Summary of Submissions to Proposed Amendment C149 and Recommended Responses

The two tables below provide a summary of the 106 submissions received to proposed Amendment C149, along with a discussion and recommended response.

The second table provides an overview of Council's response to a range of submissions received from FOLKS with regards to the Strategic Development Site (Corner of Burwood Highway and Scoresby Road). This includes the following submissions: 22B, 26B, 28, 52-75, 76A, 77, 78, 80-91, 92A, 92B, 94-96

Figure 2: Knox Central Built Form Framework Plan

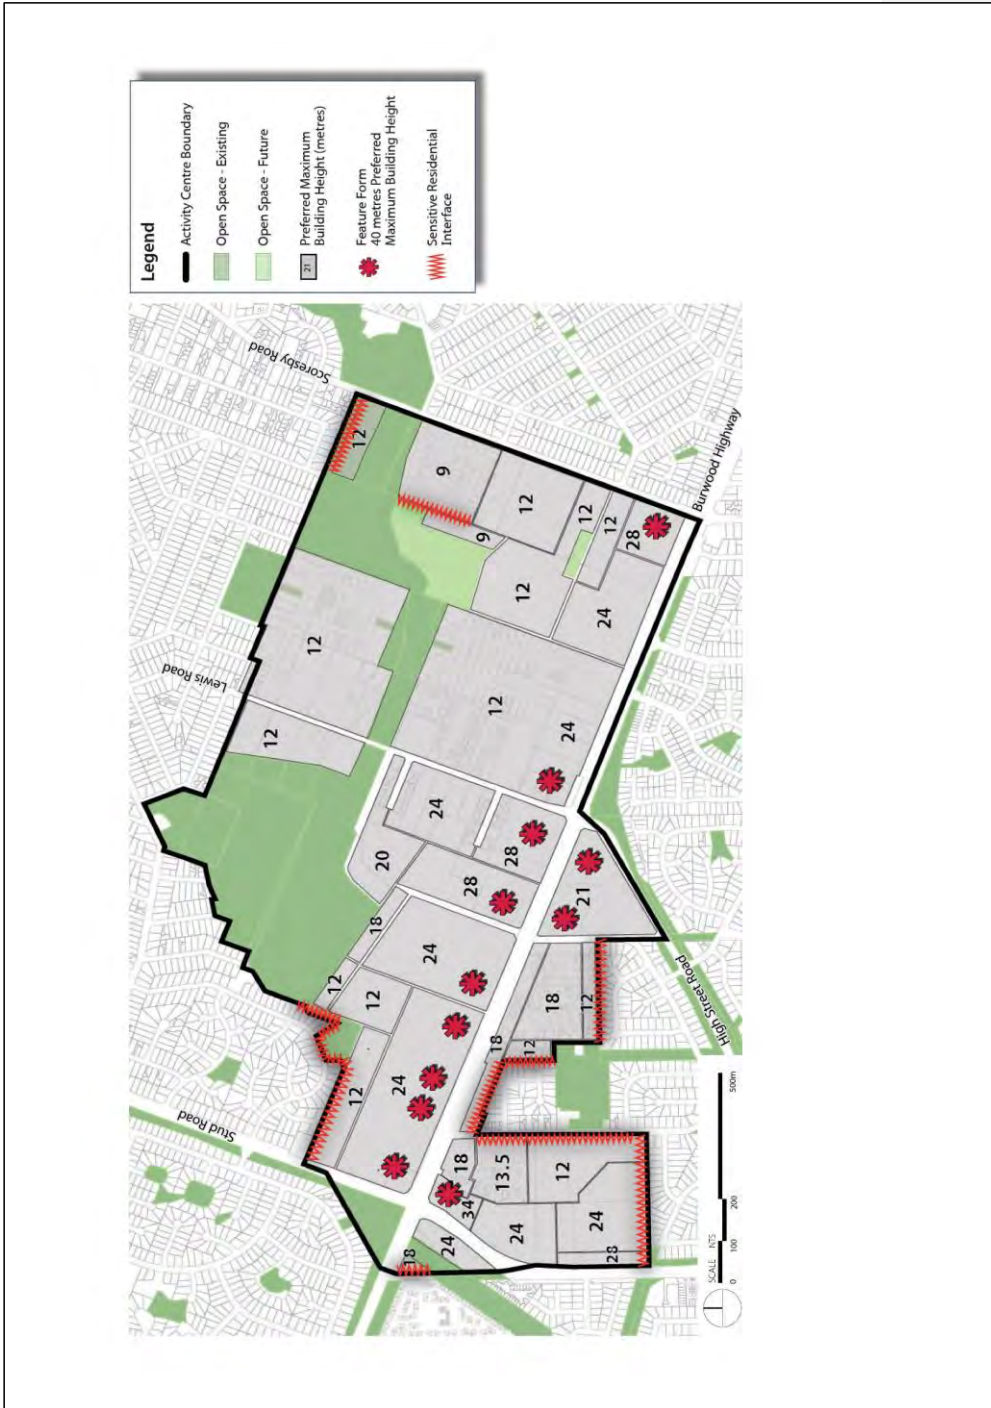
No.	Submission Source	Submission Summary	Discussion and Recommendation
034	Consultant (on behalf of landowner)	Broad support of Amendment C149. Requests that the height requirement in the DDO13 is amended to reflect the requirement of the Residential Growth Zone that applies to the site (on Jackson Road)	Accepted. Requirements in relation to building heights and car parking in the DDO should be discretionary to allow for design flexibility. RECOMMENDATIONS: 1. Preferred heights in the Structure Plan and the DDO be amended to show a preferred height limit of 13.5m (up from 12m) for properties in White, Jackson and Tyner Road within the Residential Growth Zone. This will provide greater clarity within the planning scheme as it is consistent with the zone (which has discretionary height controls); and additional modelling undertaken in response to this submission does not show a substantial increase in development potential with the change in preferred heights by 1.5m – based on the application of ‘ResCode’ provisions. 2. In order to provide clarity about the nature of the preferred heights change the DDO: “A building height must not exceed the heights... ” to “A building height should not exceed the heights shown in Figure 2 ”.

50	Consultant on behalf of landowner - Place of Worship	<ol style="list-style-type: none"> 1. Overall supportive of amendment, including the support for places of worship in CI22.15 and DDO13. 2. Concerned that an increasingly residential context has the potential to impact operations. Requests that noise attenuation measures in DDO13 will protect existing uses in this area. 	<ol style="list-style-type: none"> 1. Noted 2. Noted, no change recommended. <p>The noise attenuation measures in the proposed DDO13, along with EPA regulations in relation to noise will ensure that existing operations can continue.</p>
51	landowner (Villa Maria)	<ol style="list-style-type: none"> 1. Objects to DDO13 and mandatory height, and other design controls (such as 'car parking must be underground or concealed') as they are more restrictive than the current planning scheme. Seeking clarity whether height limits are mandatory or discretionary. 2. Concerns regarding current planning permits with height limits approved higher than the controls in DDO13. 	<ol style="list-style-type: none"> 1. Accept. Council officers clarified the nature of the proposed building heights with the submitter in January 2017. Requirements in relation to building heights and car parking in the DDO should be discretionary to allow for design flexibility, and we recommend relying on a general objective relating to car parking rather than a specific design requirement. 2. Noted. The discretionary nature of the proposed controls, and recommended changes in response to this submission should address these concerns. <p>RECOMMENDATIONS: Change the DDO as follows: Delete the following design building design requirement "Car parking must be underground or concealed so that it is integrated into the overall built form." The following general design objective will remain "To minimise the visual impact of car parking, services and access when viewed from the public realm." In order to provide clarity about the nature of the preferred heights change the DDO: "A building height must not exceed the heights..." to "A building height should not exceed the heights shown in Figure 2".</p>

A building ~~should~~ **must** not exceed the heights shown in Figure 2.
